SUBJECT: NuScale Power, LLC Supplemental Response to NRC Request for Additional Information No. 151 (eRAI No. 8974) on the NuScale Design Certification Application

NuScale Supplemental Response to NRC Request for Additional Information eRAI No. 8974

NRC Question No.: 03.08.04-23

Figure 3.7.2-169: In-Structure Response Spectra at the Reactor Flange Tool Base, Node 6329, due to X, Y, and Z Inputs of Capitola Excitation for Soil Type 7, Cracked Condition

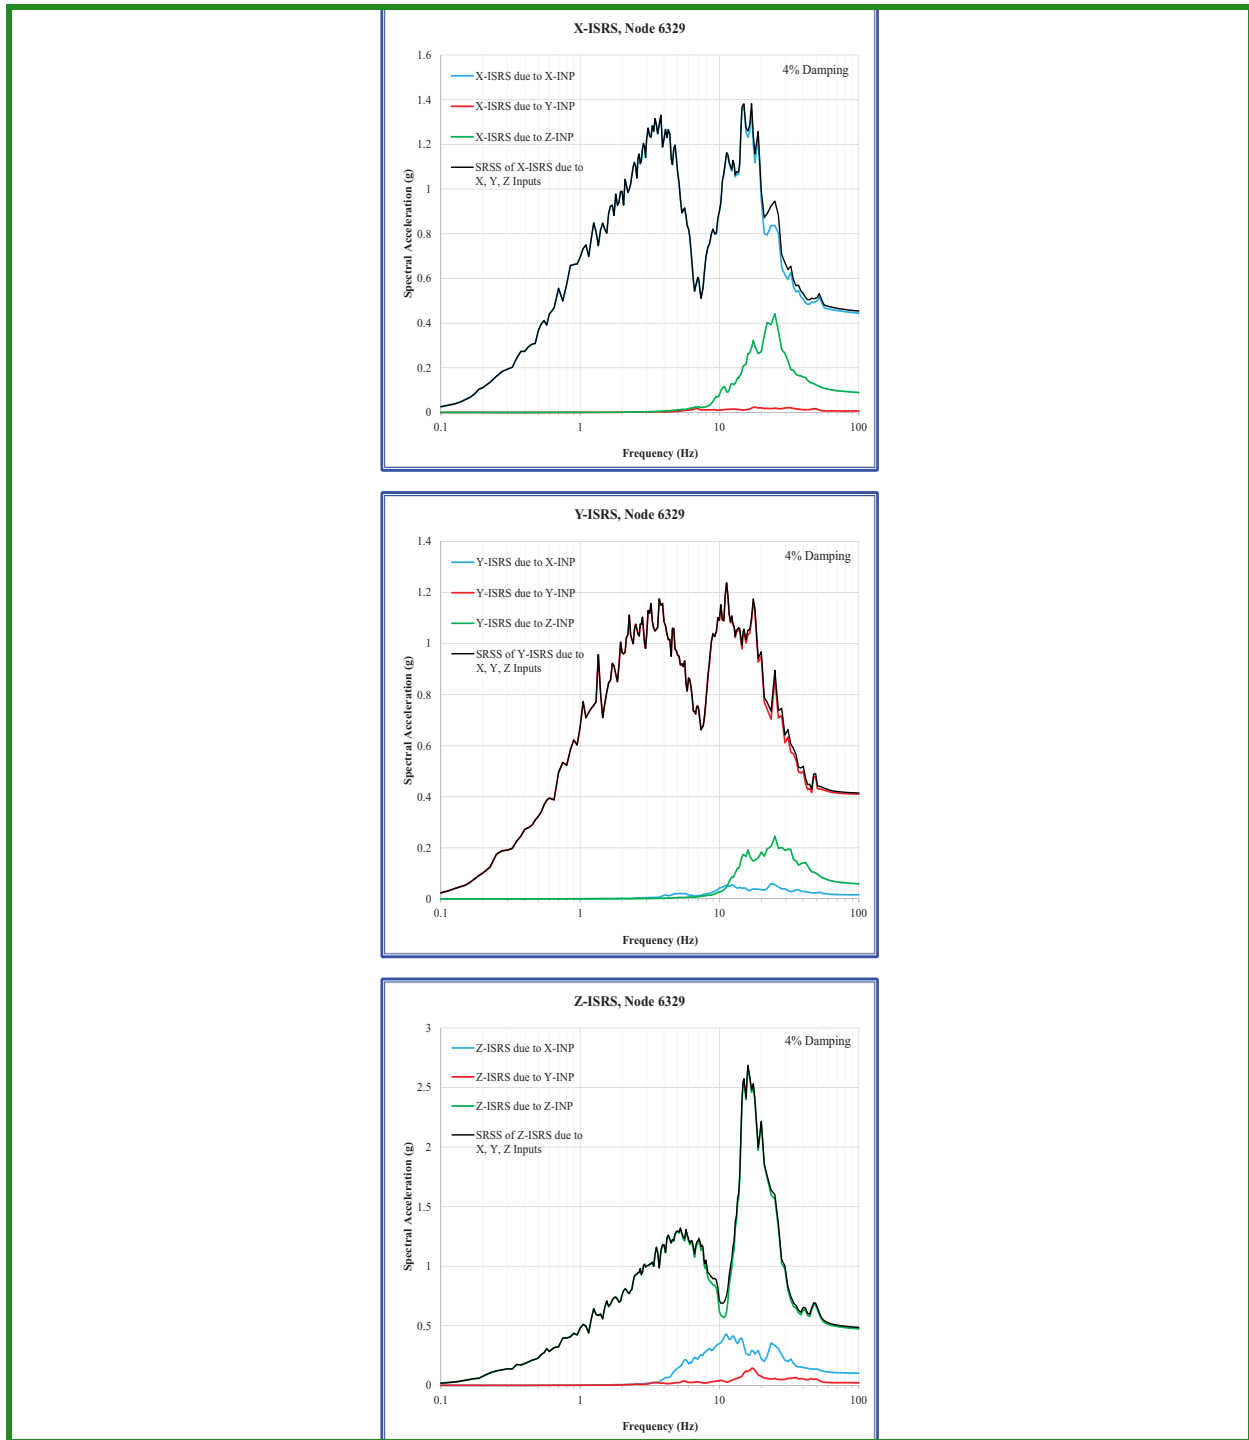
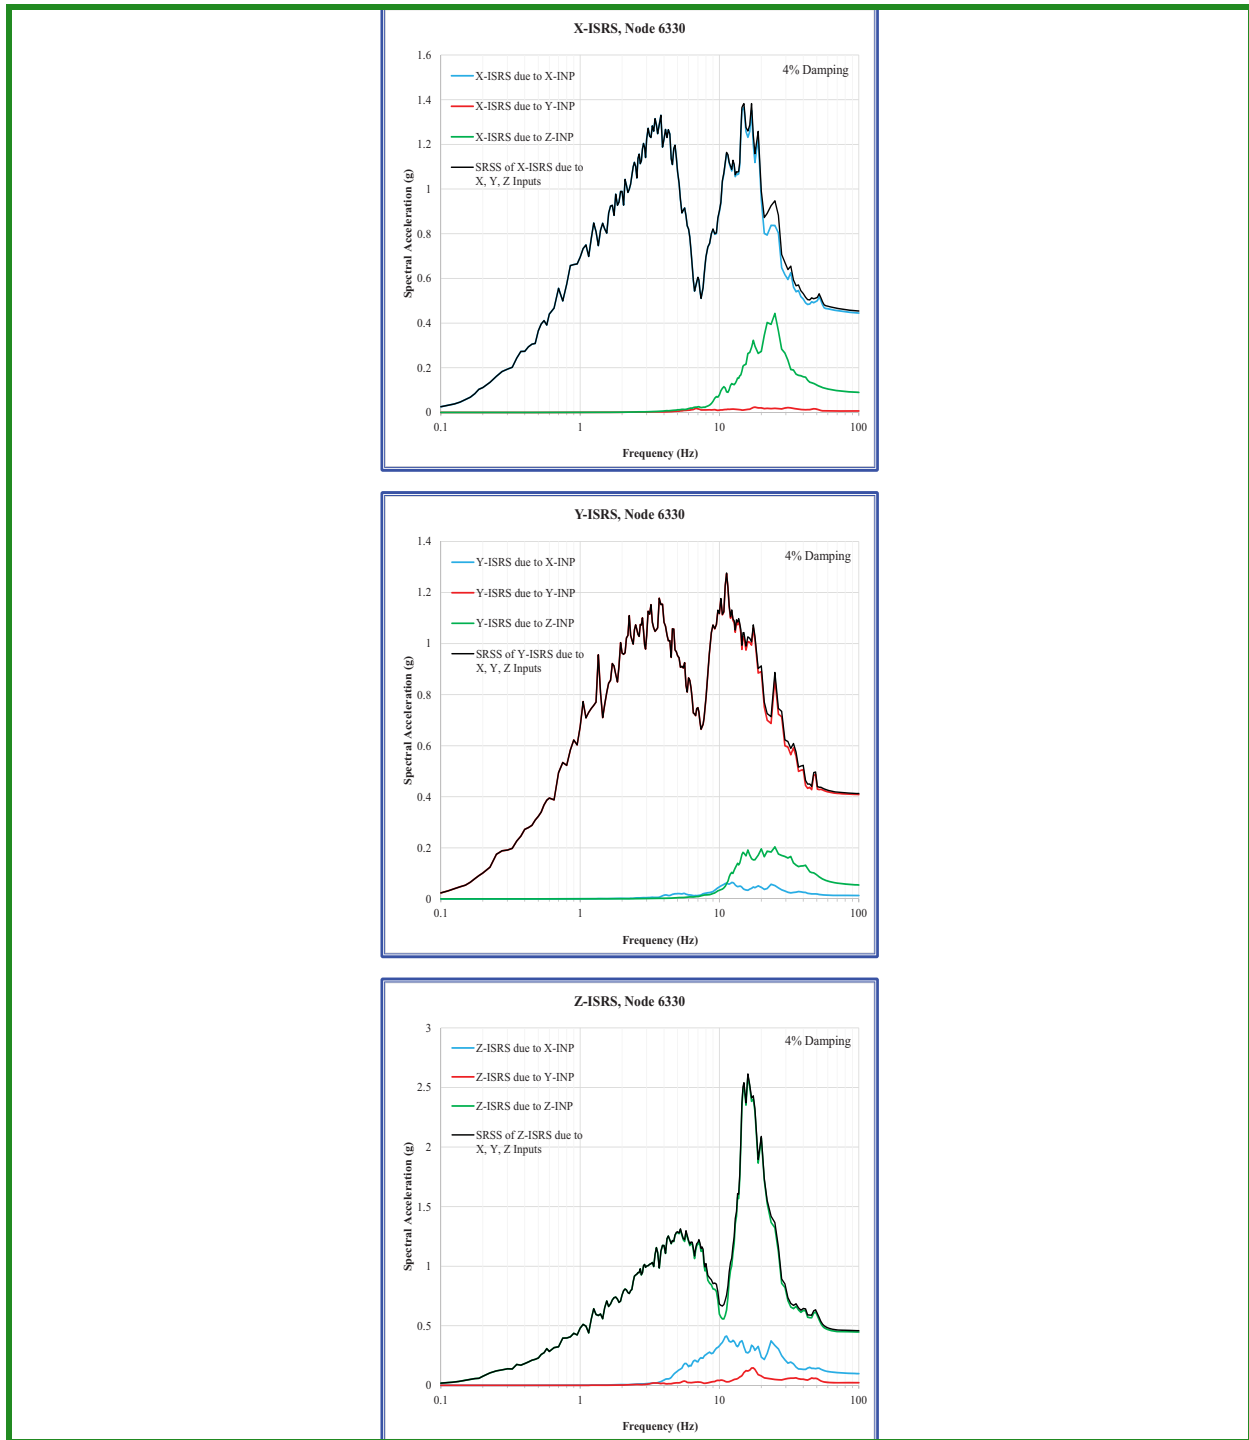
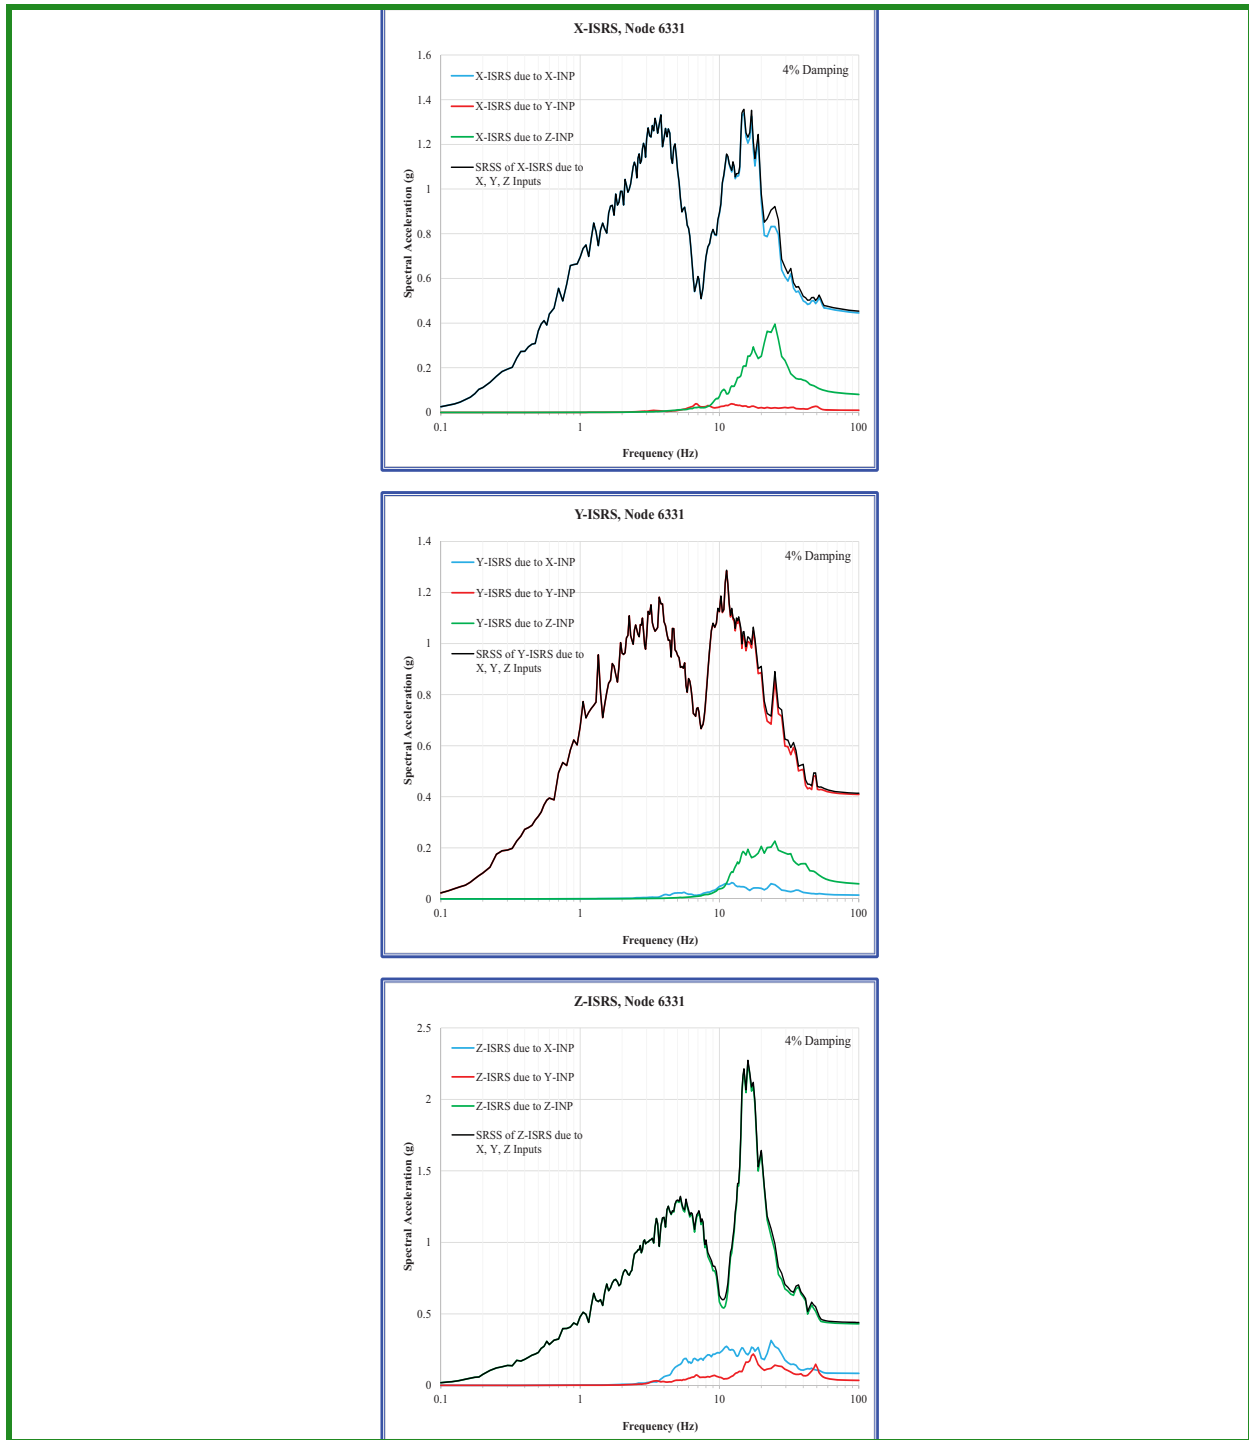
Consistent with the description for COL item 3.8-2, please include the ISRS for the skirt supports, lug restraints, and RFT base in the ISRS list for the RXB (i.e. the ISRS list related to COL item 3.8-2). Also, please include the ISRS for the bioshield.

FSAR Tier 2, Section 3.8.4.8 has been revised to include, within the list of RXB design parameters/results, the ISRS at the skirt supports, lug restraints, RFT base and the bioshields.

- FIRS Compare to Figure 3.7.1-1 through Figure 3.7.1-4
- ISRS at the reactor pool floor Compare to Figure 3.7.2-108
- ~~ISRS at the NPM lug restraints~~ ~~Compare to Figure 3.7.2-116~~
- ISRS at the RBC wheels Compare to Figure 3.7.2-114
- ISRS at grade Compare to Figure 3.7.2-111
- ISRS at the roof Compare to Figure 3.7.2-113
- ISRS at the NPM skirt supports Compare to Figure 3.7.2-156 and Figure 3.7.2-157
- ISRS at the NPM lug restraints Compare to Figure 3.7.2-158 through Figure 3.7.2-163
- ISRS at the RFT base Compare to Figure 3.7.2-164 through Figure 3.7.2-171
- ISRS at the bioshields Compare to Figure 3.7.3-4a through Figure 3.7.3-4c
